1965 Corvette: Service Bulletin: Turn Signal Switch - Failure to Cancel

Subject: Turn Signal Switch - Failure to Cancel

Bulletin Number: DR #706, Section XII

Date: October 26, 1964

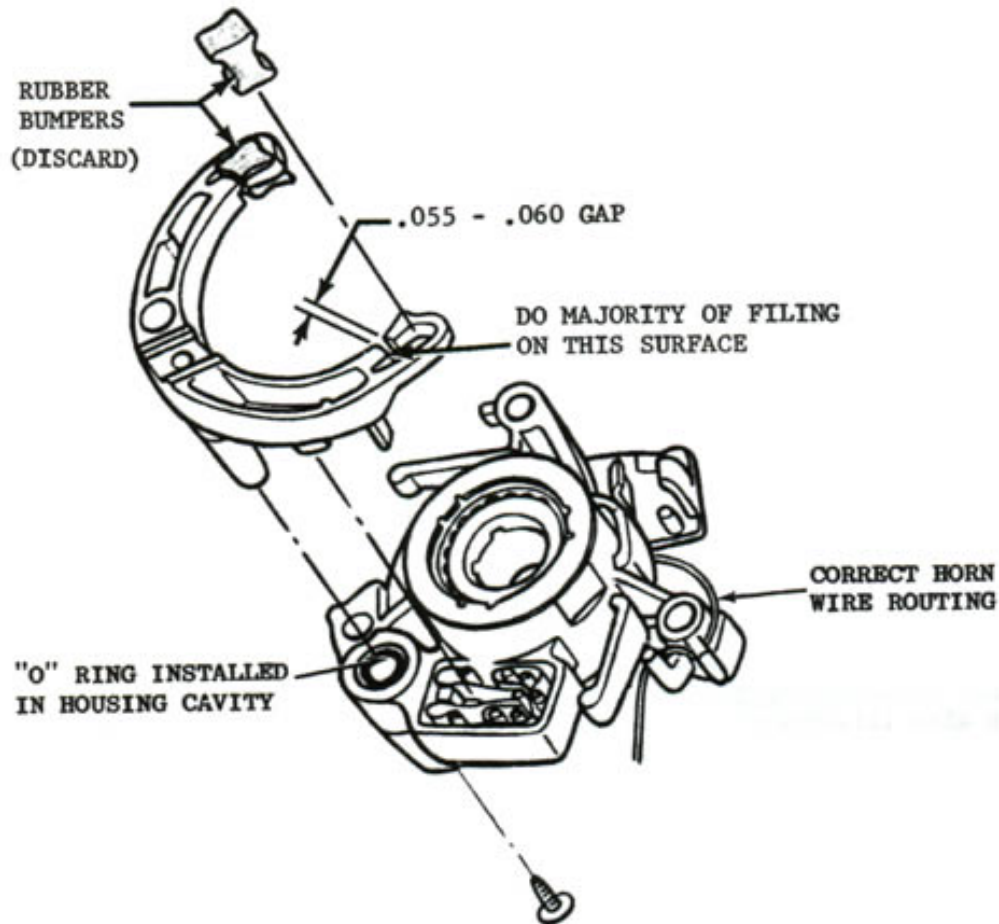
Early production 1965 vehicles, except Chevelle, may exhibit a "failure to cancel" or a "partial cancel" condition of the turn signal switch assembly. This condition is prevalent from the right turn position and caused by a number of variables within the switch assembly. The cancelling cams are not the cause of the malfunction.

A complete failure to cancel is obvious but when partial cancel occurs, the turn signal lights will go out but one brake light will be inoperative. This could easily be incorrectly diagnosed as a bulb, socket, or wiring failure.

It should also be noted that if for any reason the actuator lever is removed from the switch body, the "O" ring must be placed in the body cavity (as shown on the attached sketch) when reinstalling the lever. The correct horn wire routing is also illustrated in the sketch.

1. Remove steering wheel (refer to Section 9 of Shop Manual).

2. Remove and discard both rubber bumpers from the actuating plate (see sketch).
3. Using a small file, such as an ignition point file, open the gap in the cancelling pawls to .055/.060 (rework both sides). NOTE: After cleaning any flash from the moveable arm face, perform the stock removal from the stationary arm.
4. Blow out loose filings with air hose.
5. Replace the steering wheel, temporarily, and test the switch for cancelling.
6. If the switch now works correctly, reinstall the steering wheel. If the switch still fails to cancel, it will be necessary to replace the switch assembly (Part No. 910821).
